# Special Community Board Meeting 7 May 7pm Ohariu Valley Hall

## Questions to Meridian

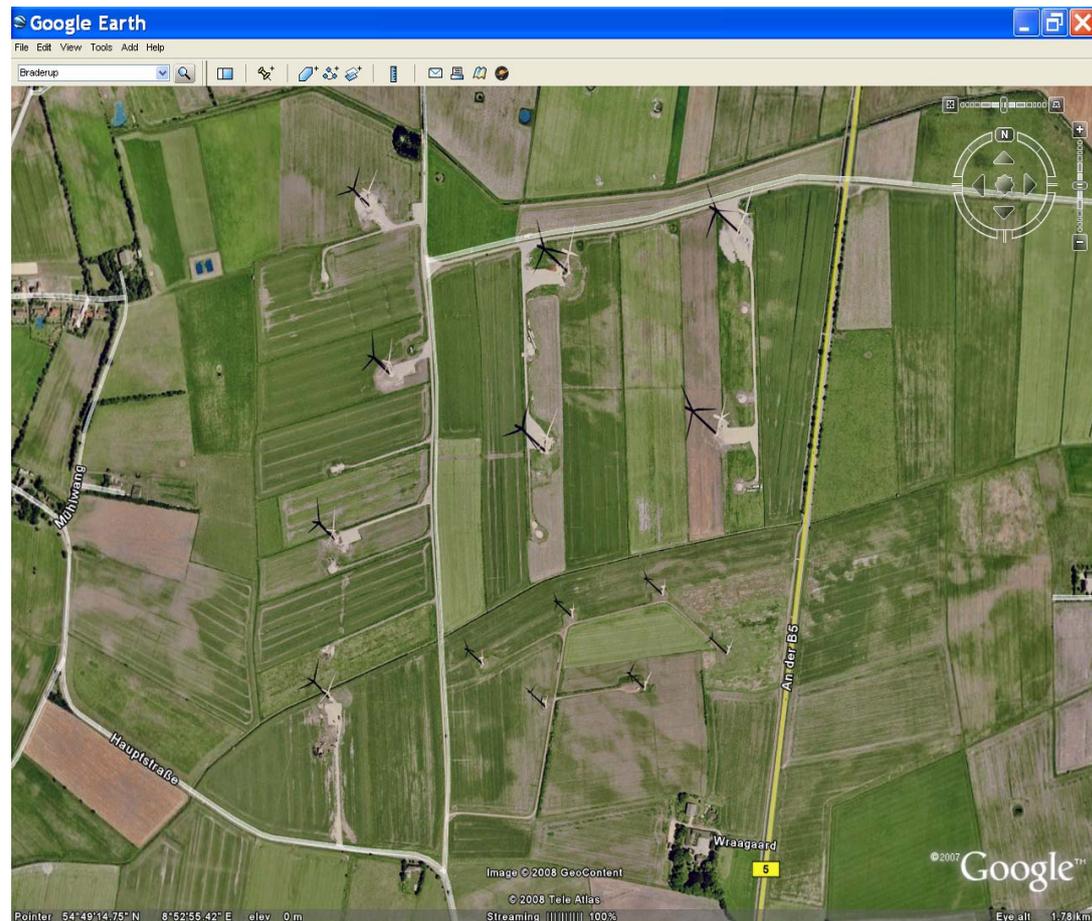
1        *The AEE states that recent background noise shows that at 6mps wind speeds at the turbines, conditions of under 25dBA have been indicated at certain residential testing points in the Valley. It then says that according to Project West Wind conditions a sub-6808 noise restriction of 35dBA would apply at residences. The application does not mention that the West Wind condition, the wind speed at the residence must be less than 1.5mps for this to apply. Do you think that the 1.5mps wind speed at the residence restriction is necessary, and if so, why.*

The ongoing work relating to West Wind with the measurement of wind speed and noise levels within the valley will indicate whether the requirement to measure wind speeds in the valley is necessary.

Additional measurements have been undertaken at four locations (to date) for the Mill Creek Project which include wind speed measurements close to two of the noise measurement locations. This data is currently under review.

If the West Wind conditions, including the “sub6808 conditions” were adopted for Mill Creek there would be a requirement to measure local wind speed to determine the times when the local conditions were less than 1.5 m/s.
